City of Portland, Oregon
Bureau of Development Services
Land Use Services
FROM CONCEPT TO CONSTRUCTION

NOTICE OF A TYPE II_x DECISION ON A PROPOSAL IN YOUR NEIGHBORHOOD

CASE FILE NUMBER: LU 17-179331 LDS

The applicant is proposing a 4-lot land division for attached dwelling units. The existing house on the site will be demolished. No onsite parking is currently proposed or required due to the sites proximity to frequent transit service (Bus #19 along NE Glisan). However, parking may be proposed at the time of building permit submittal if future access to onsite parking can meet the requirements of the Portland Bureau of Transportation (PBOT).

CASE NO. 17-179331
 EXHIBIT C-1

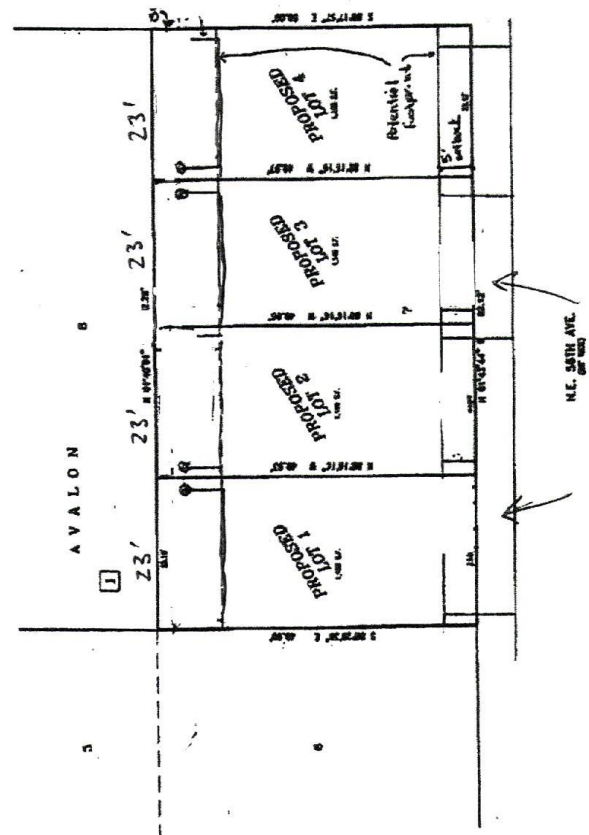
23' - drywall - Must meet all
 BES requirements

Planner Note: No On-Site parking approved!
 Parking not required. If
 On-Site parking is proposed in
 Correlation with building permit,
 applicant must meet PBOT requirements.
